NEPEAN RIVER FLOODPLAIN RISK MANAGEMENT STUDY & PLAN INCLUDING NARELLAN CREEK

APPENDIX K – PUBLIC EXHIBITION RESPONSES

Final Report (13 November 2022)

The comparison of the actual flood level and the flood mapping from Nepean River FRMSP Draft Study

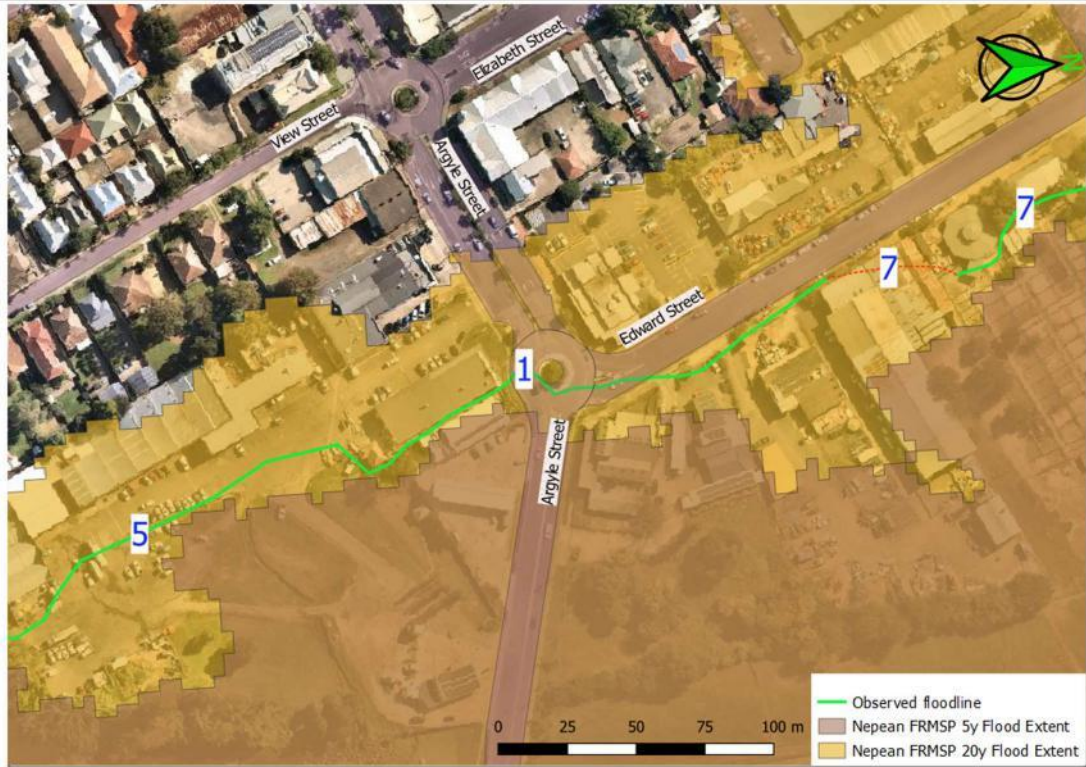
Based on historical flood data, the Cowpasture Bride Gauge level of 12.3m corresponds to approximately an event closer and lower to 6.5 year.

The comparison of flood extents from March 2022 flood photos and the Nepean River FRMSP flood mapping shows that the flood extents are consistent with the flood event indicated from the gauge justifying the validity and the accuracy of the Nepean River FRMSP flood mapping.
